SERVICE BULLETIN

APPLICABILITY: 2013-19MY BRZ

NUMBER: 09-54-12R

SUBJECT: High-Pitched “Chirp,” “Squeak” or “Cricket”
 Sound from the Engine

DI FUEL PUMP ASSEMBLY

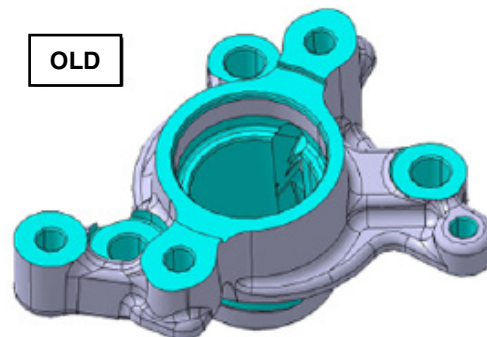
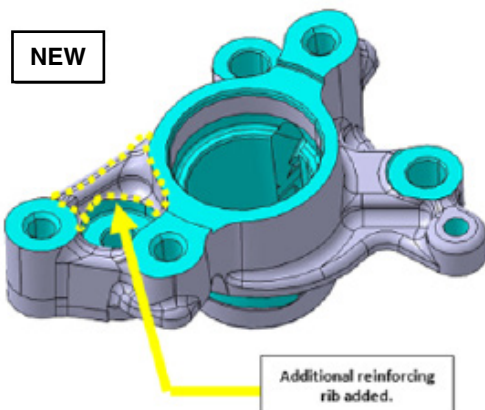
Top View of New (Flat Top Plate) High-Pressure Fuel Pump

Identifying the most up-to-date pump from previous versions using the numbers found on the Top Plate:

- For Production Line installed Pump:**
Current and Previous (both): 16625JB000
Current: 296100-0291 Previous: 296100-0290
- For Replacement / Service / Repair Part:**
Current: 16625JB022 Previous: 16625JB021
Current: 296100-0491 Previous: 296100-0490

PUMP DRIVE CASE ASSEMBLY (Check Table Above for Applicability)

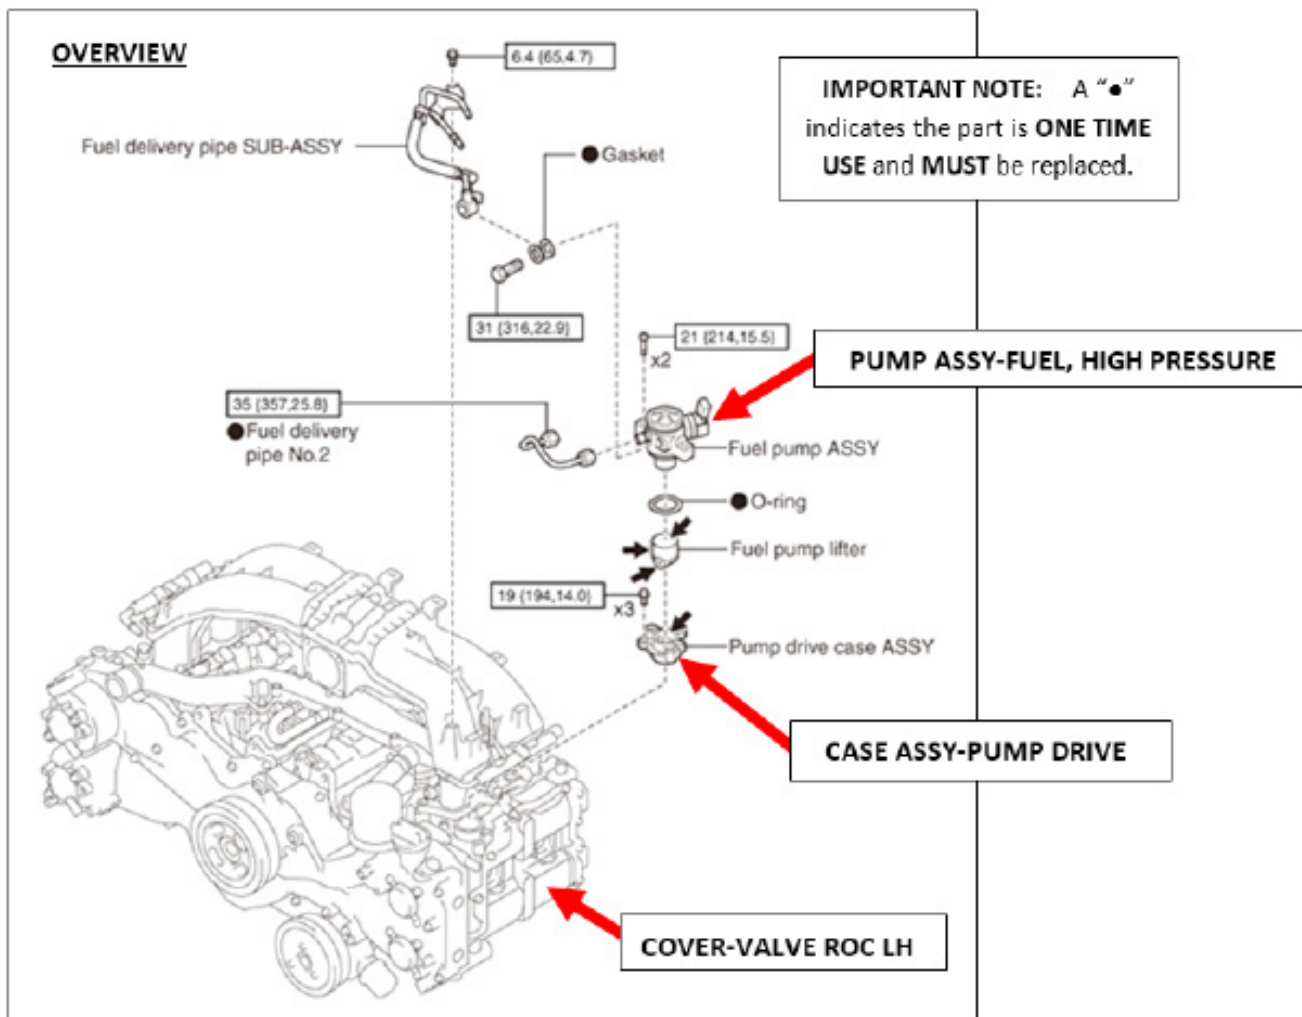
VIN RANGE	REQUIRED PART REPLACEMENT(S)		
	DI Fuel Pump	Drive Case	Rocker Cover LH
Prior to F*603025	YES	YES	YES
F*603026 to F*603363	YES	NO	YES
F*603364 to G*604648	YES	NO	NO
